Staff Summary Report

SUBJECT: Hold a public meeting for a Development Plan Review for **SUNRISE PRESCHOOL (PL080400)**, located at 1628 East Broadway Rd.

DPR08238 - Development Plan Review including site plan, building elevations and landscape

2 PROPOSED SITE PLAN

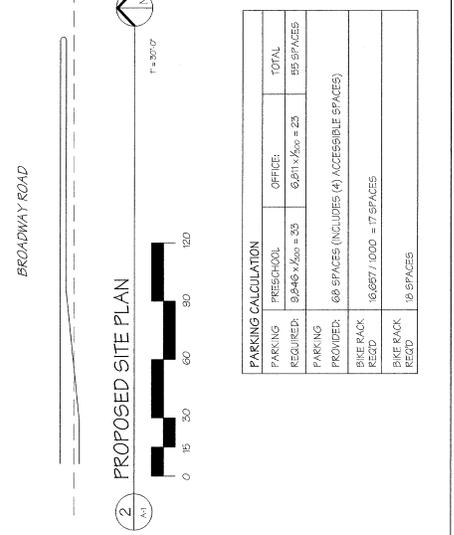
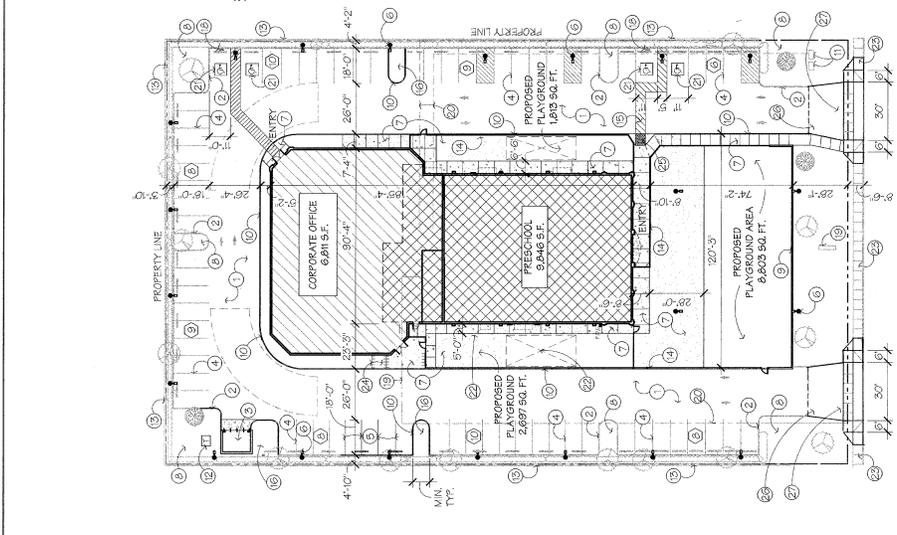
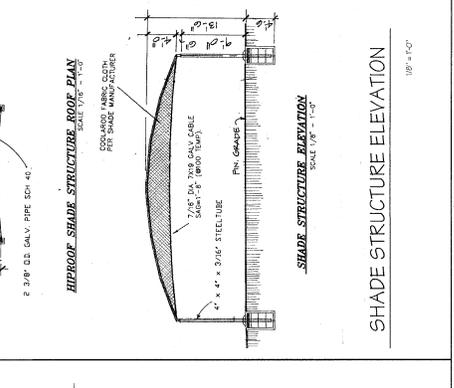
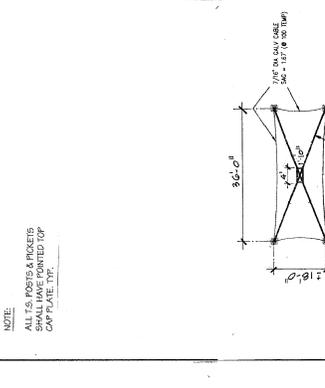
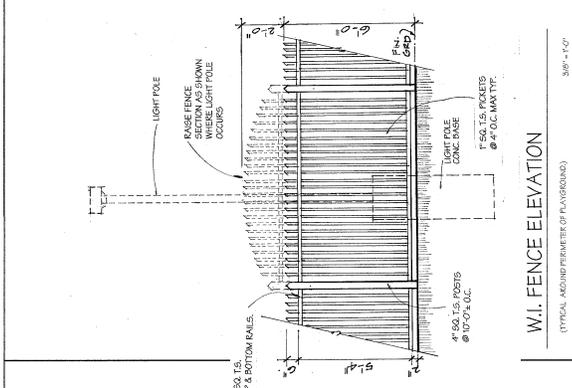
1. The shade structure elevations and final location to be reviewed with planning plan check.
2. The driveways shown on the site plan do not meet Tempe Engineering T-320 Standards. Construct new entrances to conform to current engineering standard and provide upgraded paving at each driveway apron consisting of unit paving. Extend unit paving in the driveway from the back of the accessible public sidewalk bypass to 20'-0" on site and from curb to curb at the drive edges.
3. Any freestanding utility equipment boxes for this development shall be finished in a neutral color (subject to utility provider approval) that compliments the coloring of the buildings.
4. Relocate and disperse the bicycle racks from parking lot to designated areas near building entrances. Final locations to be reviewed with planning plan check.
